### **2.2.1 Project/Site Supplemental Information**

The Erosion Prevention and Sediment Control (EPSC) Plans for the Initial, Interim, and Final Conditions (Drawings C-026 through C-037) have been revised to remove all proposed EPSC measures from the three (3) identified streams and to place additional controls adjacent to the streams. The revised EPSC plans accompany this supplemental information.

WASTEWATER TREATMENT PLANT EXPANSION  
BLEDSOE COUNTY CORRECTIONAL COMPLEX  
PIKEVILLE, BLEDSOE COUNTY, TENNESSEE SBC PROJECT 142/013-01-2013-06

| DRAWING NO. | C-030.1           |

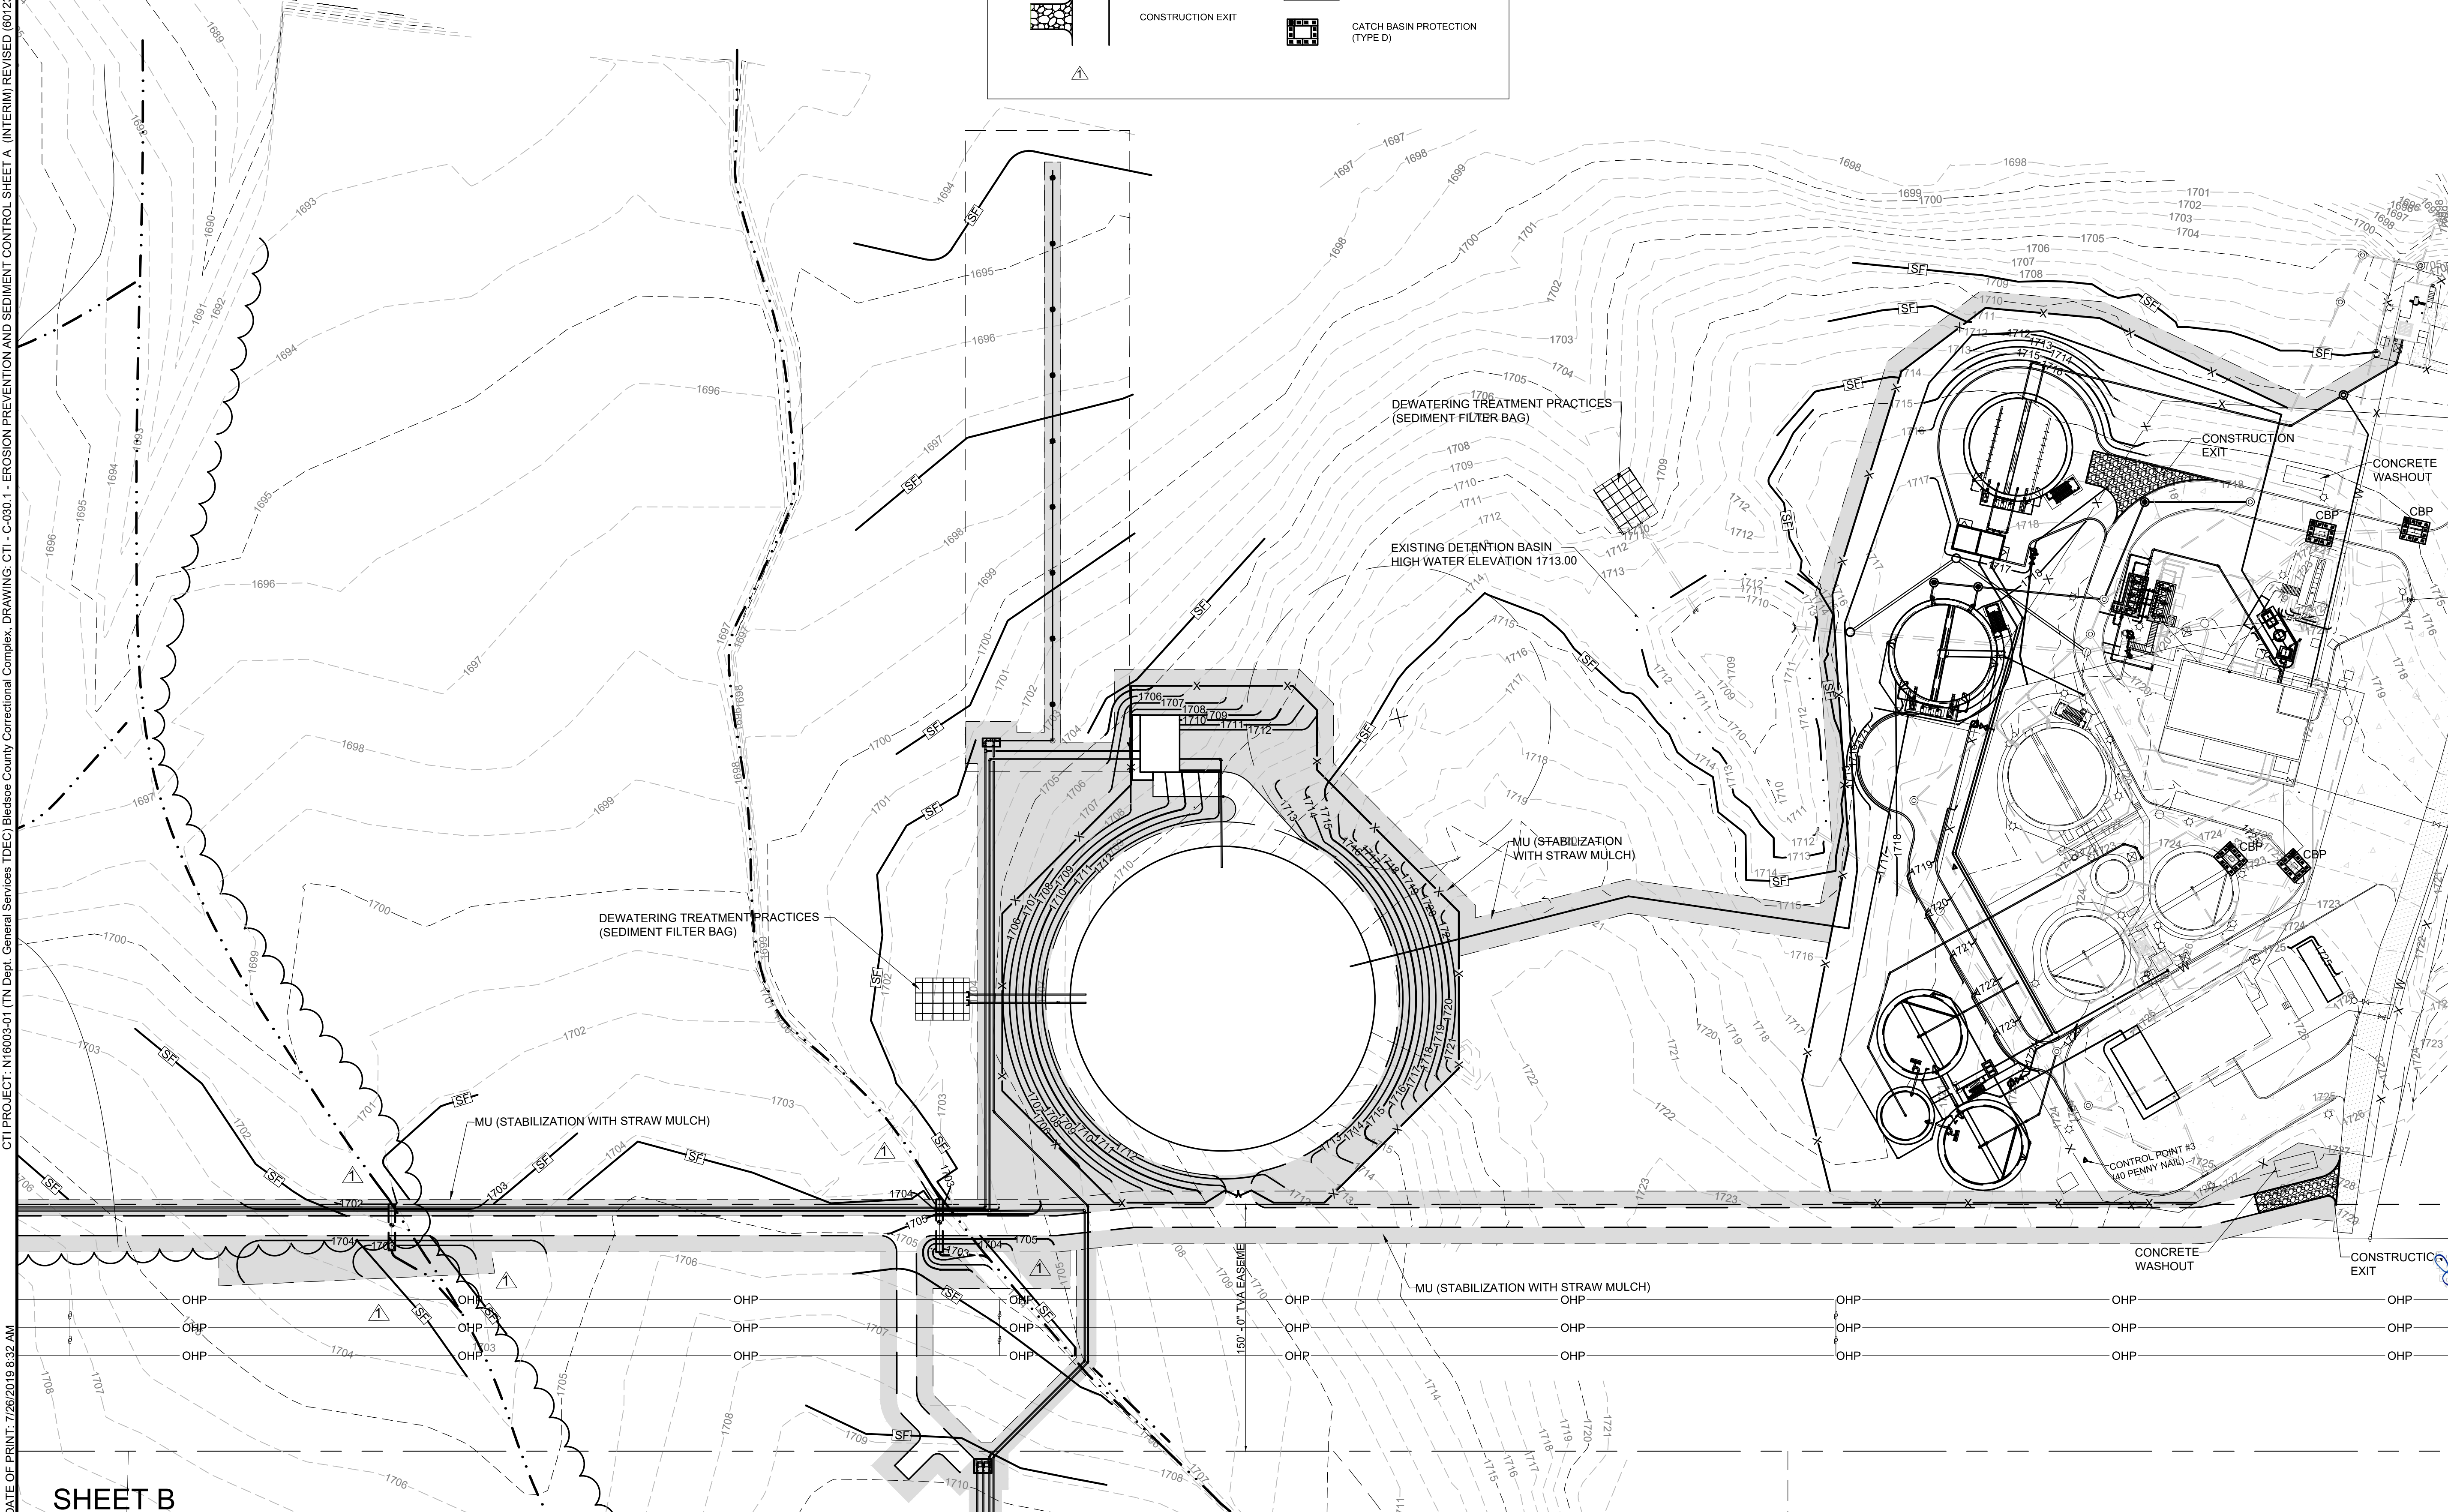
| REVISIONS |  | DESIGN |         |
|-----------|--|--------|---------|
| 1         | REMOVED EPC MEASURES FROM DESIGNATED STREAMS, ADDED EPC MEASURES ADJACENT. | JRH    | 7/25/19 |
| 2         | REVISED LEGEND.  | NH     | 7/25/19 |

| DRAWING NO.<br>C-031.1          |

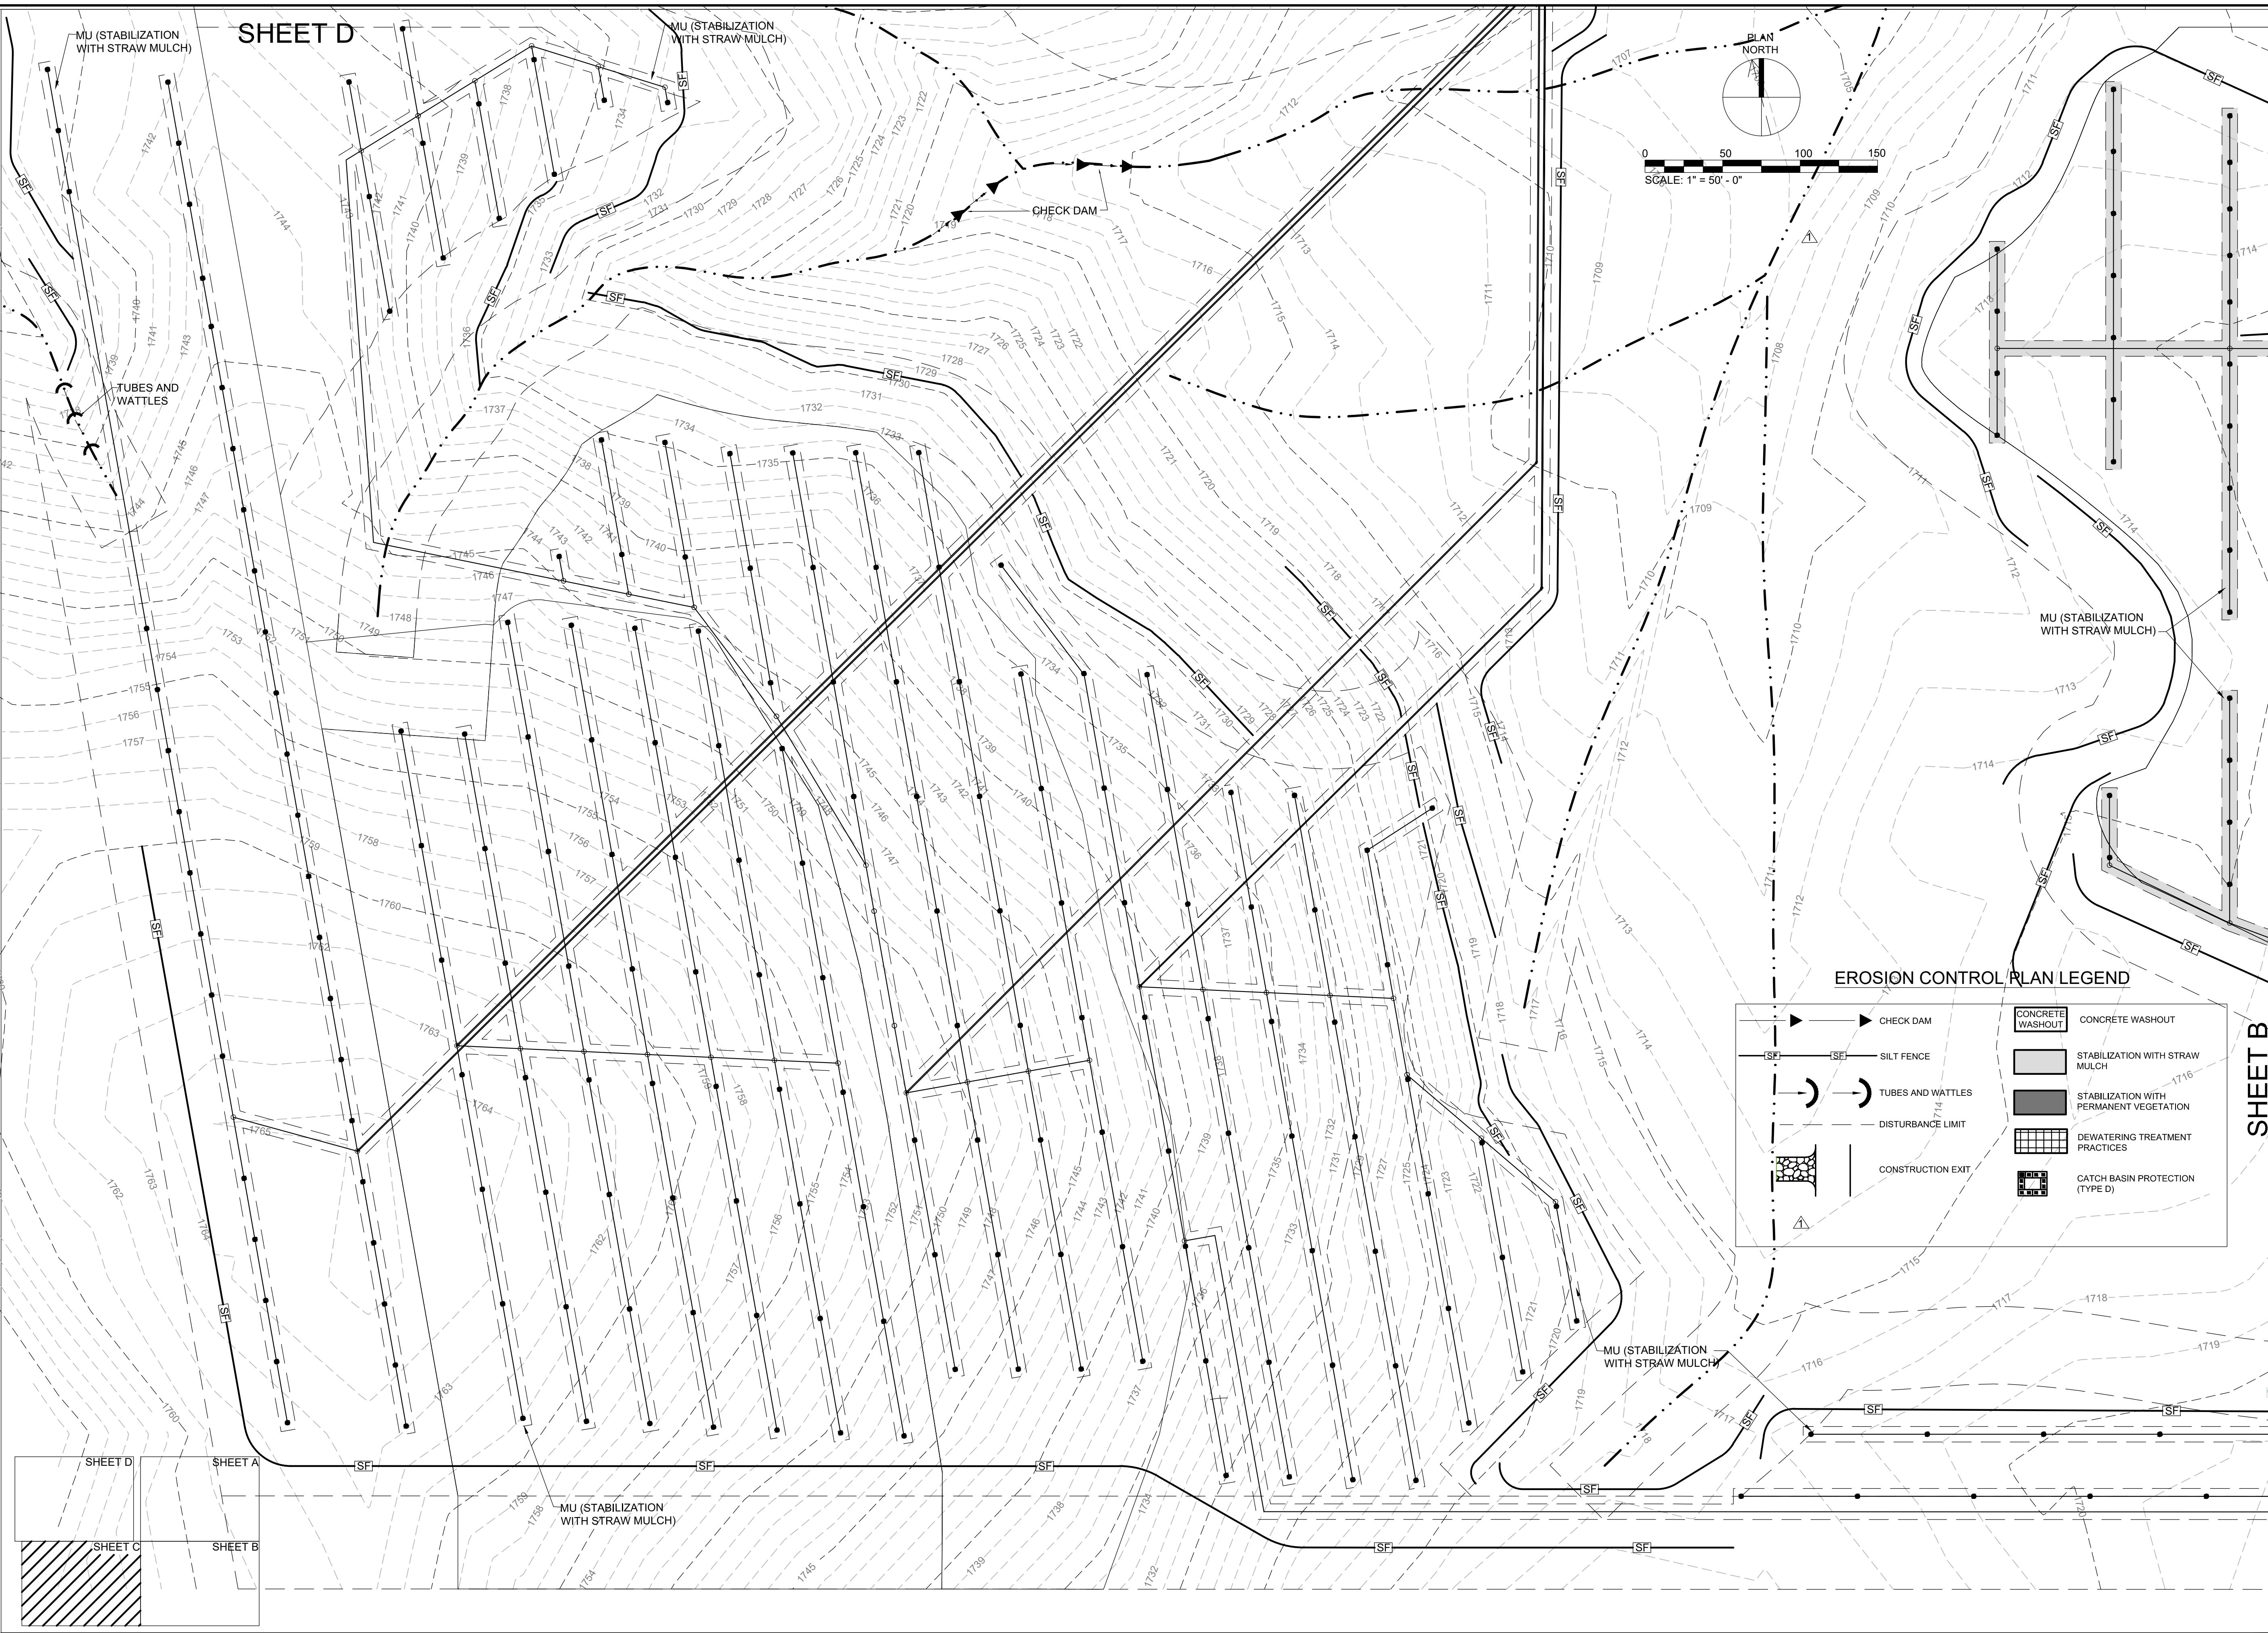
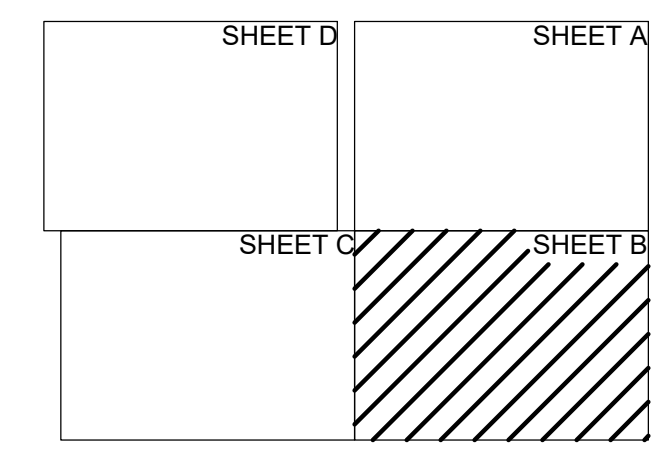
| DESIGN |         | REVISIONS |  |
|--------|---------|-----------|--|
| NH     | 7/25/19 | 1         | REMOVED EPSC MEASURES FROM DESIGNATED STREAMS. ADDED EPSC MEASURES ADJACENT. |
| NH     |         |           | REVISED LEGEND.  |
